**From:** Scala, Mary Joy  
**Sent:** Thursday, October 22, 2015 4:20 PM  
**To:** 'Bill Banowsky'  
**Cc:** 'Robert Crane'; 'Patrick Carpenter'; Veronica Koltuniak (veronicakoltuniak@gmail.com); Jack Horn, Jr.; Fabio, Craig  
**Subject:** BAR Action - 200 W Main Street - October 20, 2015

**RE: Certificate of Appropriateness Application**

BAR 15-10-04

200 West Main Street

2 Section at Marquee  
3/4" = 1'-0"

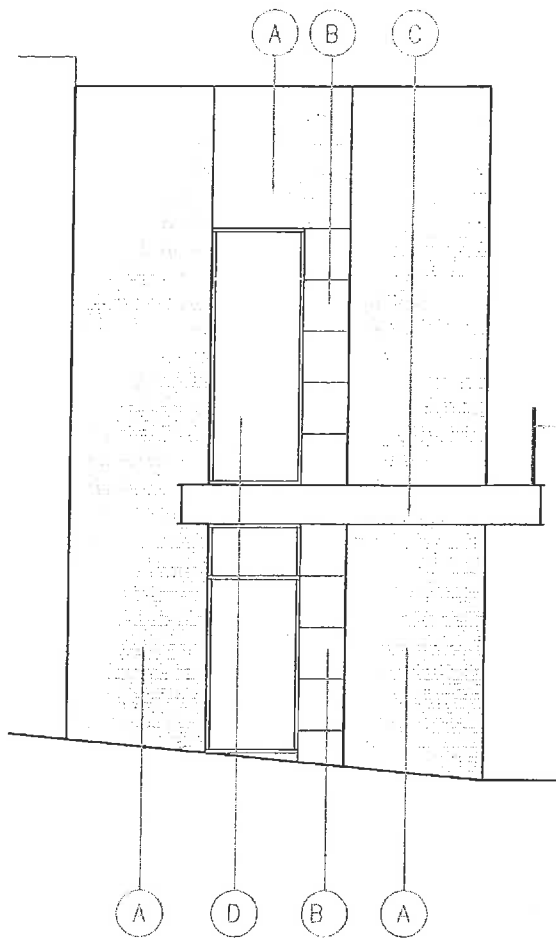
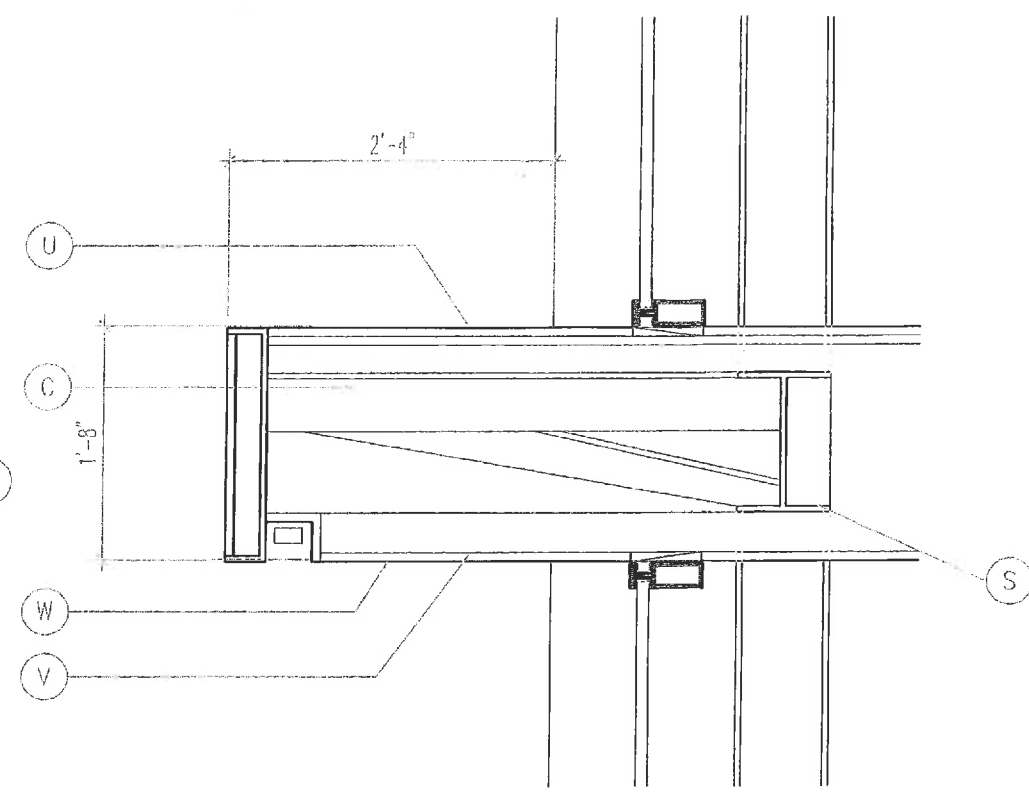
1. The Hardie panels – the BAR requests a change in finish with higher contrast, different texture, and much lighter [color];
2. The marquee depth – the BAR wants to see alternative trim or other detailing in order to lighten the appearance ;
3. The [tinted] glass shall be a clear glass;
4. The smaller transom on the east side lower window shall be revised [to match upper window];
5. More information in the form of a rendering for the request for paint color on 2<sup>nd</sup> Street.

- The “marquee” was approved with a depth of 1’-8”. The as-built design is approximately 36” to accommodate a drainage system. Because the marquee is deeper, the bottom window on Second Street does not match the top window as approved.

SHEET NUMBER  
**A1.50**

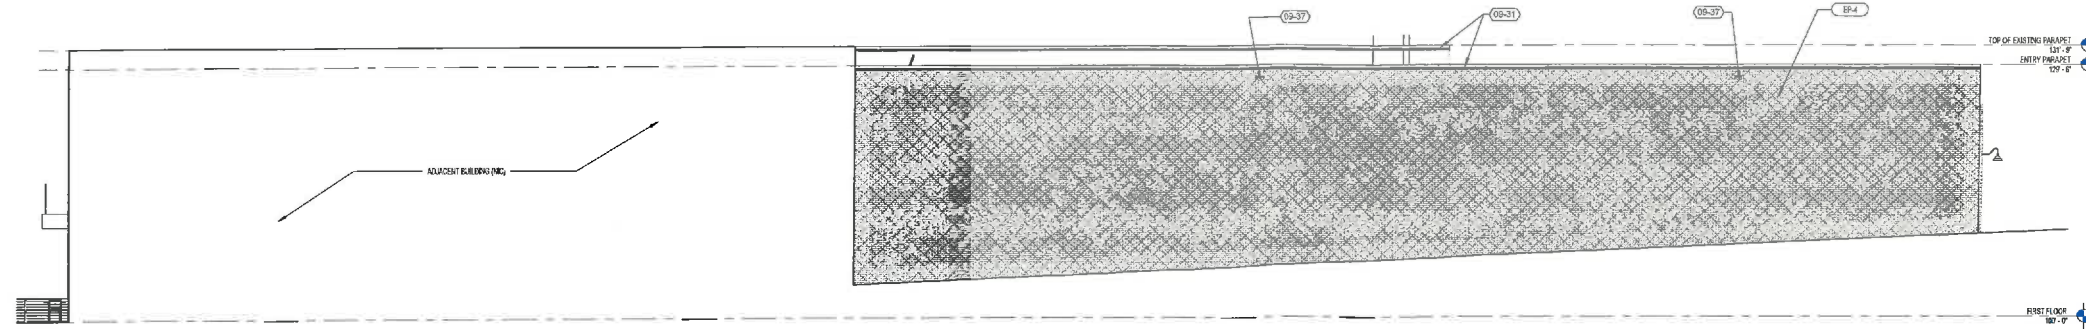
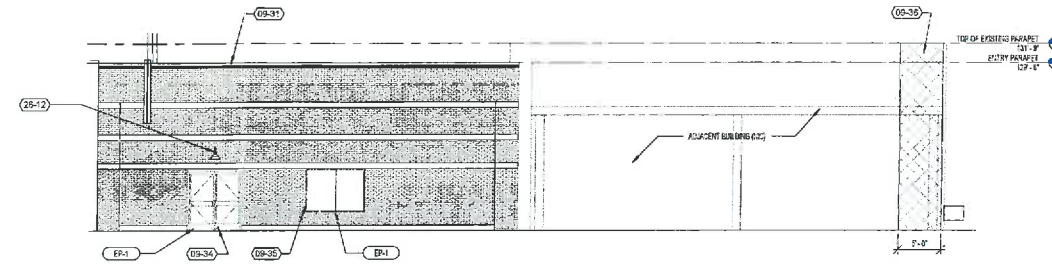
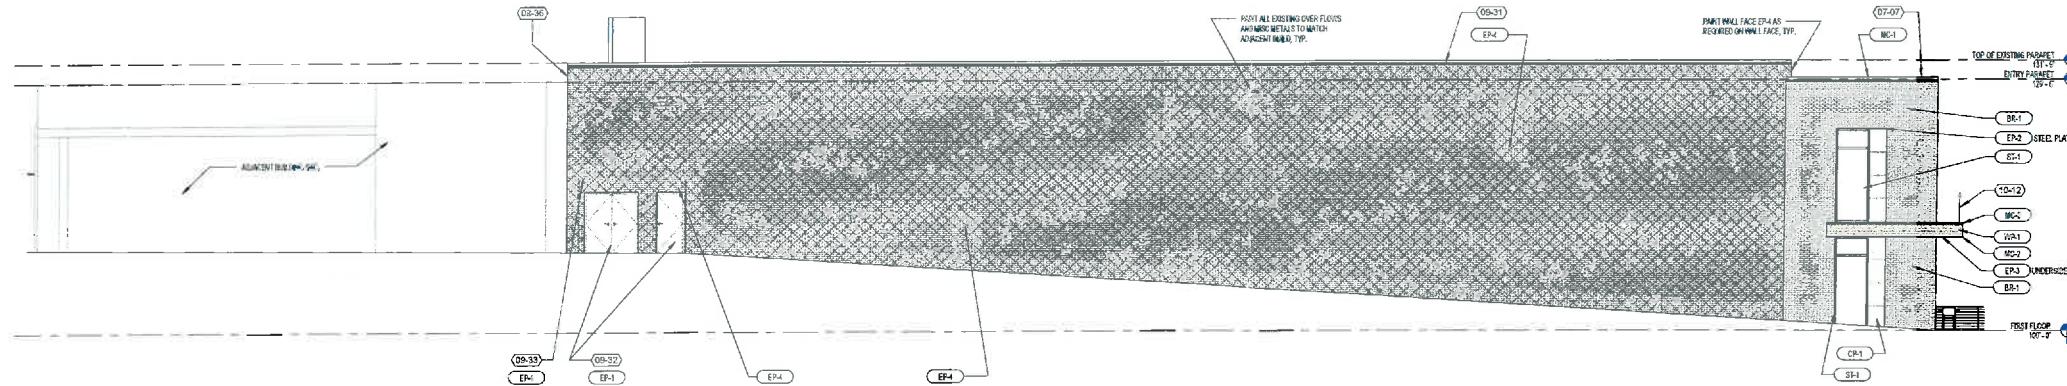
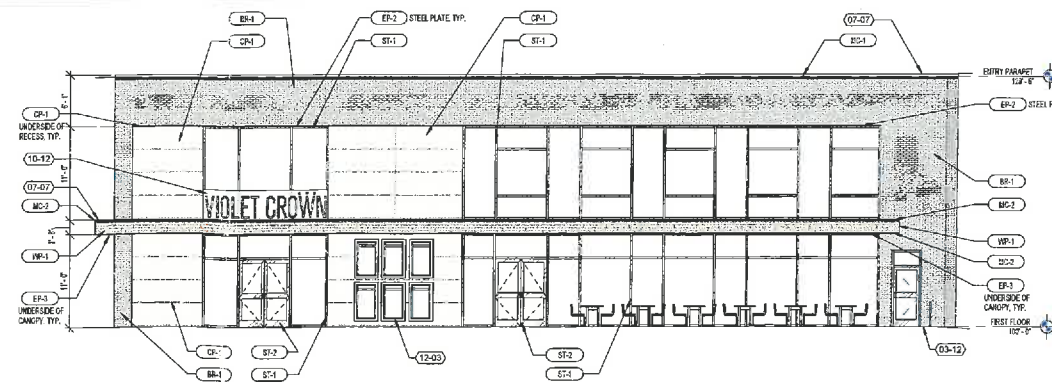
- The entrance surround and the Second Street window area were approved for ceramic panels, Lea Ceramiche, Gouache.10 in soft sand. The requested change is to substitute Hardie Plank panels painted Ashley gray in satin finish with aluminum channel.  
The original design showed ten horizontal bands. The joints on the front of the building aligned around the building corner with the joints at the side window. The as-built design consists of eight horizontal bands that do not align on the bottom window.

In addition, the applicant is requesting approval to change the existing (red) paint color of the older east side brick wall and metal service doors on Second Street SW, and the service doors and window sash on West Water Street to Benjamin Moore HC-168 Chelsea Gray satin finish. (The newer Water Street brick wall is not currently painted and is not proposed to be painted.)
